CUSTOMER TECHNICAL MEMO # 248

Subject: FS6 FACE FIT FLYSCREEN

Date: September 2015

ASSEMBLY DETAIL

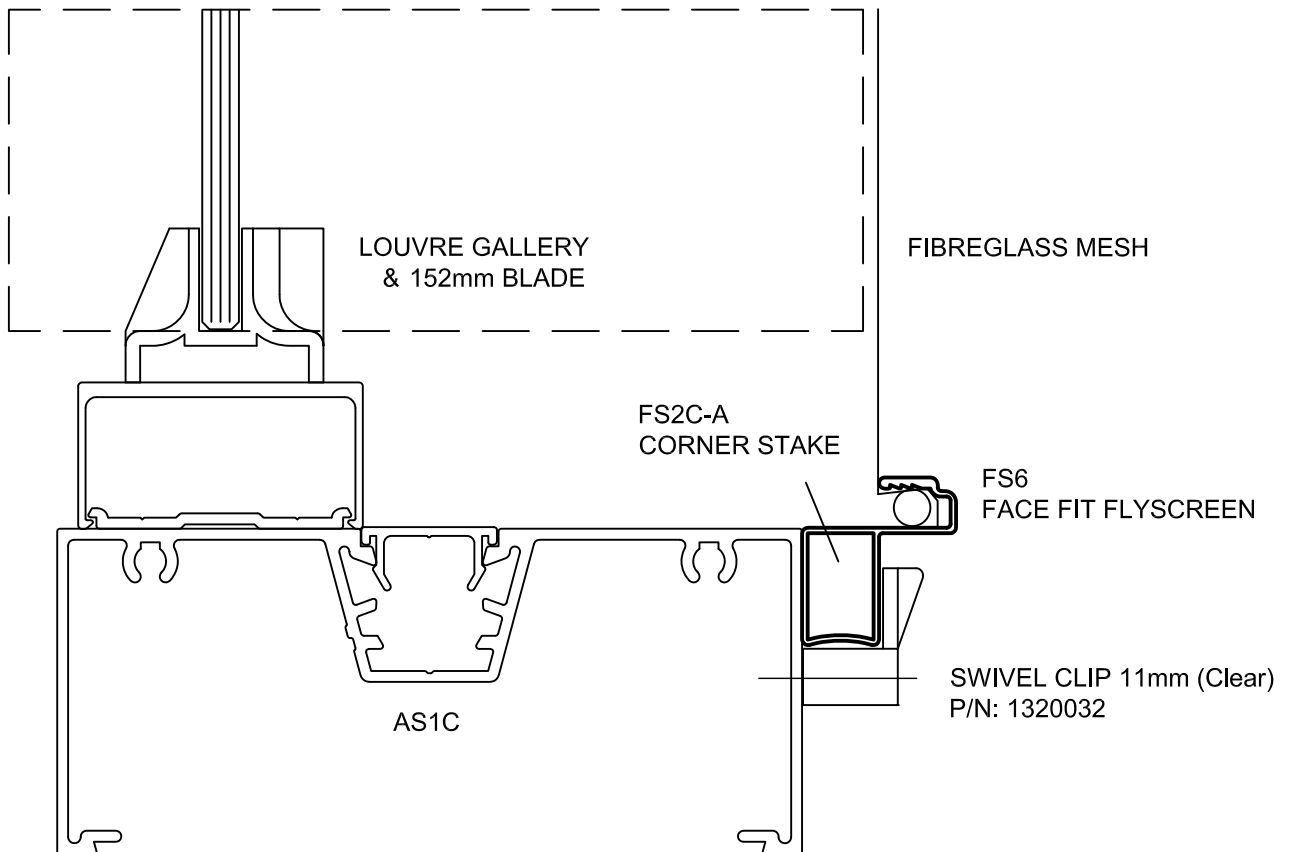
A new face fit flyscreen (FS6) has been introduced that will allow a 10mm offset from the front face of a frame.

The new FS6 face fit flyscreen will allow clearance generally for a 152mm louvre blades within a 102mm frame to fully open and operate. This FS6 can be retained on the frame with the use of multiple "Swivel Clips 11mm Clear" (1320032) to hold the screen in position and remove when needed.

FS2C-A Corner stakes (1324001) are required to assemble this FS6 frame. Standard 6mm spline is used to retain the fibreglass mesh in place.
